DM0298

MEMORANDUM TO GROUP LEADERS & CONSULTANTS

SUBJECT: New Drip Groove Location

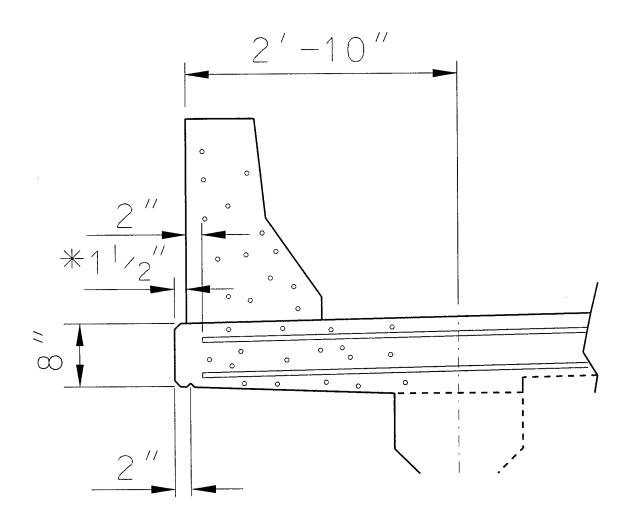
Due to a complaint from the field engineers about insufficient cover for the bottom slab reinforcing steel at the drip groove, the drip groove shall be detailed 2" from the edge of slab instead of the 3" currently being shown.

The attached sketch shows a typical condition when slip forming is used. The transverse slab bar lengths should be computed to provide 2" clear to edge of slab as currently done. This will provide 3 ½" clear when slip forming is used.

*1/2" additional slab for slip forming Barrier parapet.
